Release Note

Software Version：2.6.0

Models：i12/i16V/i18S/i23S/i30/i31S/i32V/i33V/PA2/iW30

Date：2019-09-02

1. A unified software version

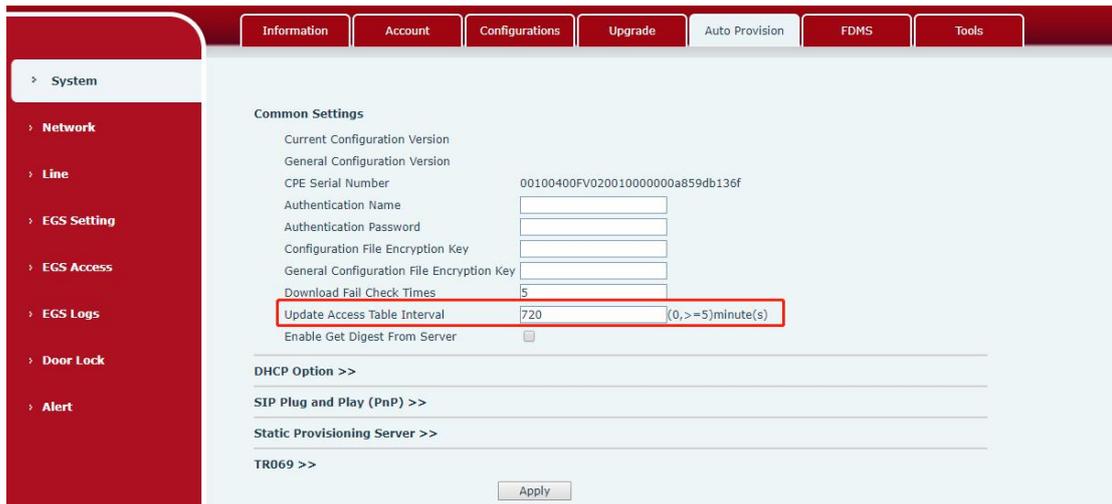
Description: Support multiple models to share a software version, when the batch deployment, multiple door phones and intercom models can be upgraded together.

2. Access list to add search and periodic update functions

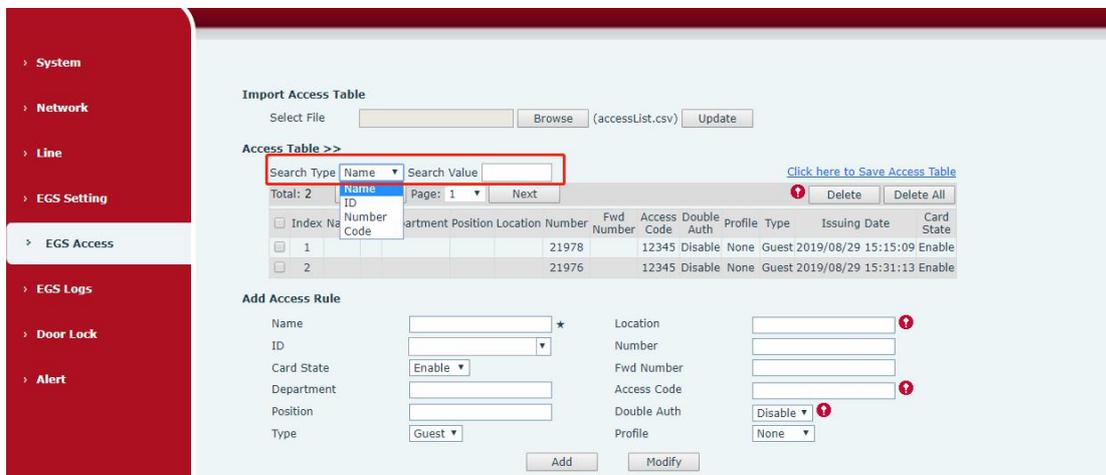
Description: You can search by name, ID, host number and authentication code. On the visit list page, select the search type, enter the search content, hit enter, and the visit list will display the searched content. Delete the search content, and you can go back to the original access list interface.

3. Add PTT functionality

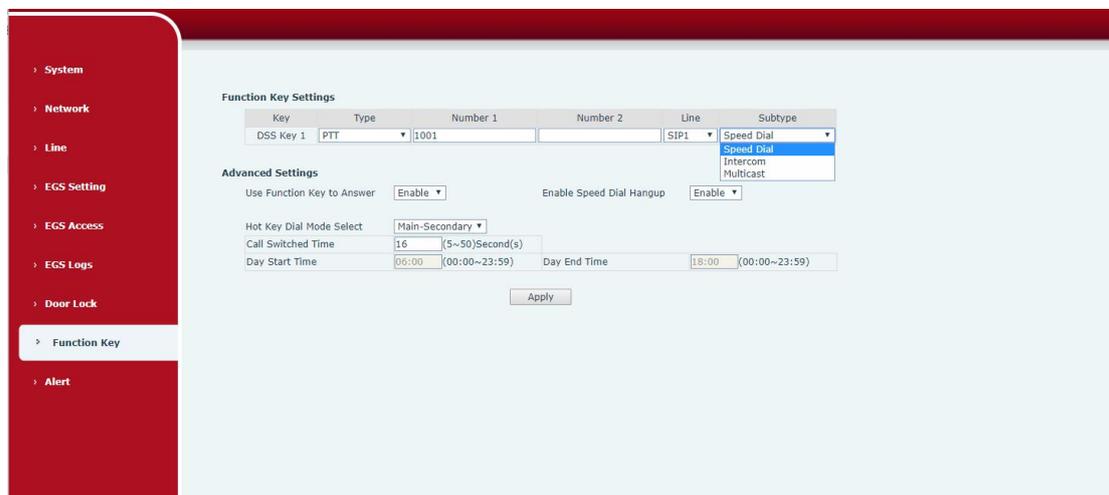
Description : When the button is pressed and held all the time, the device makes a call. When the button is lifted, the current call is immediately ended.

5. Added the function of automatic hang-up when opening the door

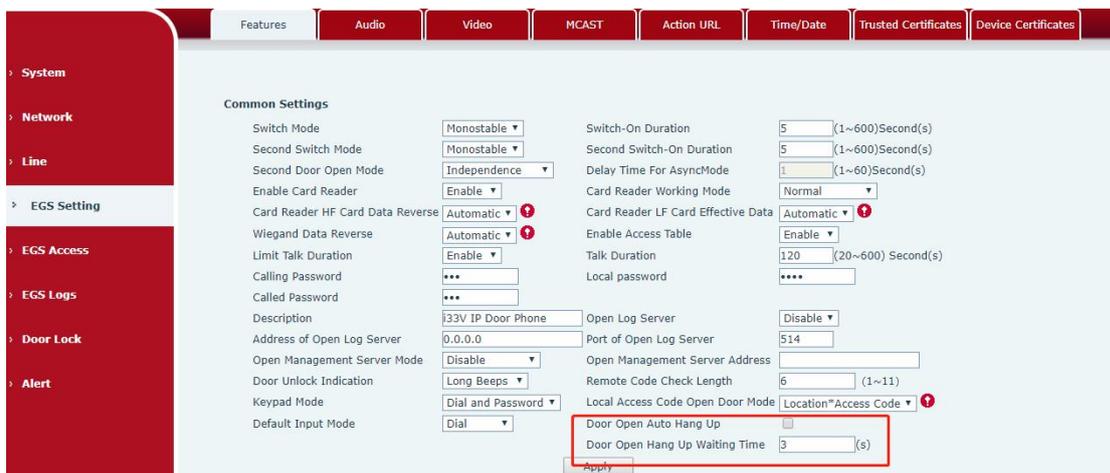
Description: Access control works as the main call to the indoor machine, and enter remote door password on the indoor machine. After opening the door successfully, the call will end automatically after the time out.

7. Dsskey Add Redial and Call Back

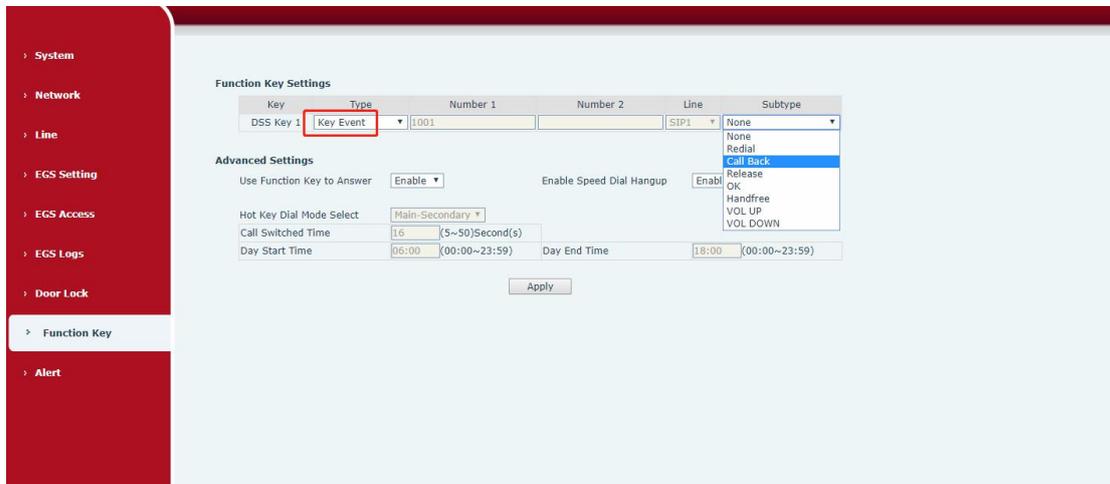
Redial: press Redial to return the last number you exhaled

Callback: press Call Back to Call Back the last number called in, either received or missed

8. Add back ring tone, busy tone control switch and custom ringtone

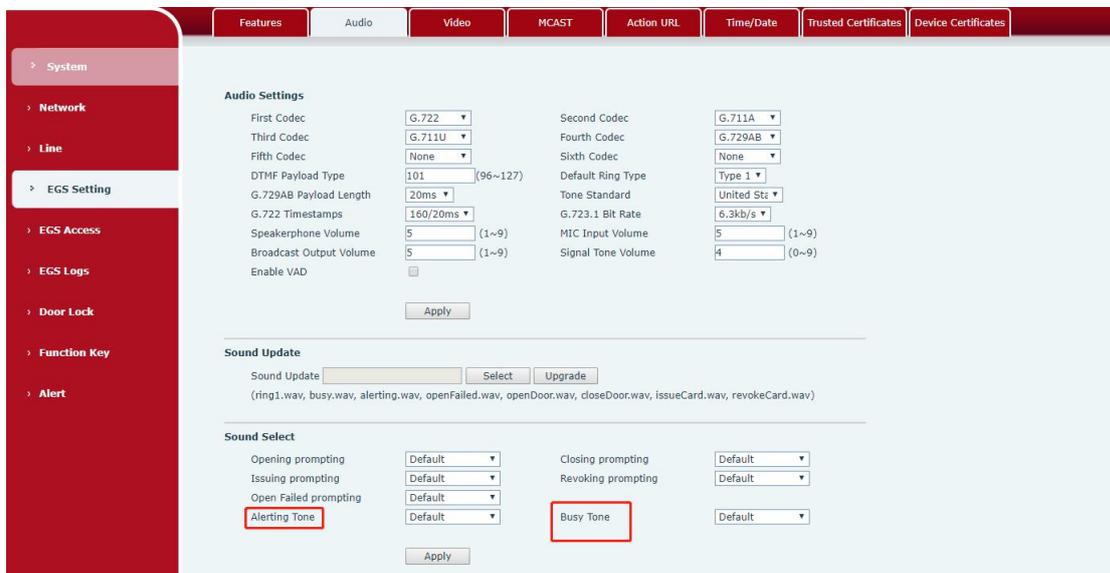
Description: Alerting tone is used to control whether to play back the ring tone, and busy tone is used to control whether to play back the ring tone.

# 9. Support to turn off prompt tone

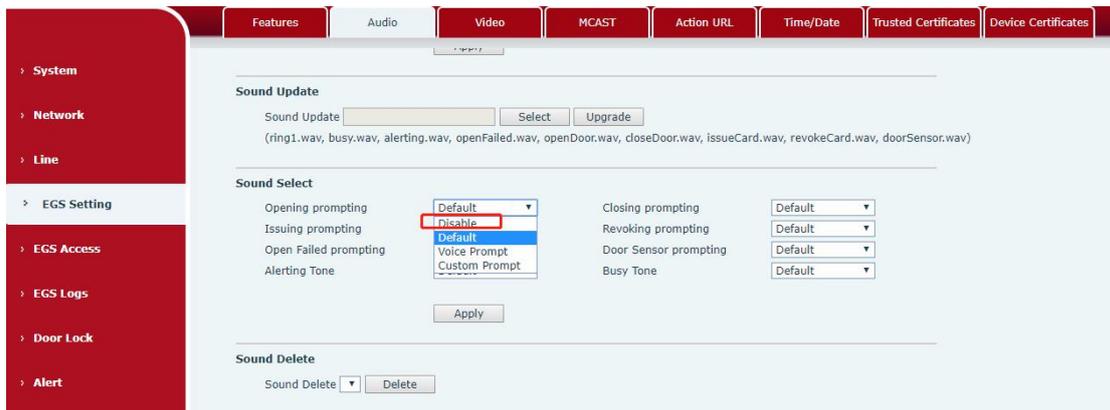
Description: EGS Setting -> Audio -> Sound Select to add a closed configuration, the default value remains the same and improved as close, preset, voice prompt mode.

10. Add a multicast prompt sound

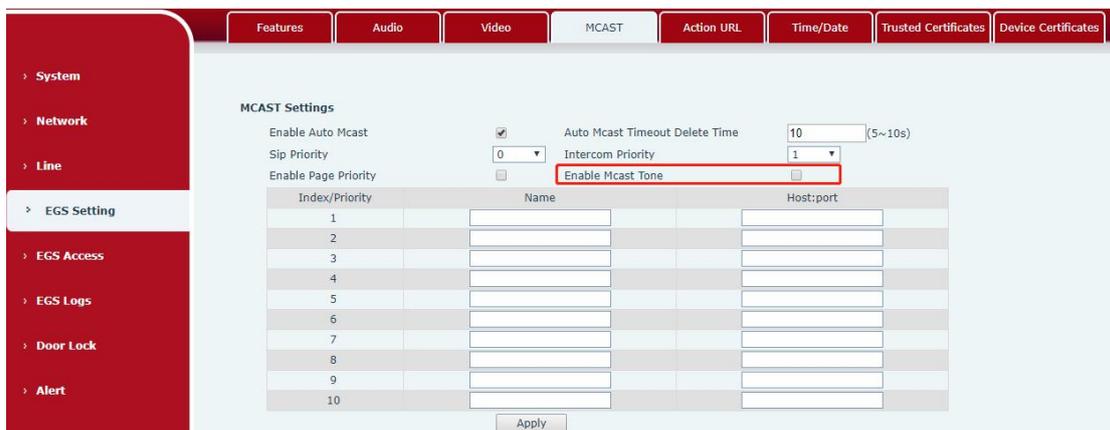
Description: When Enable Mcast Tone is enabled, there will be a prompt sound when the device receives the multicast. Turn off this configuration, there will be no prompt sound when the device receives the multicast
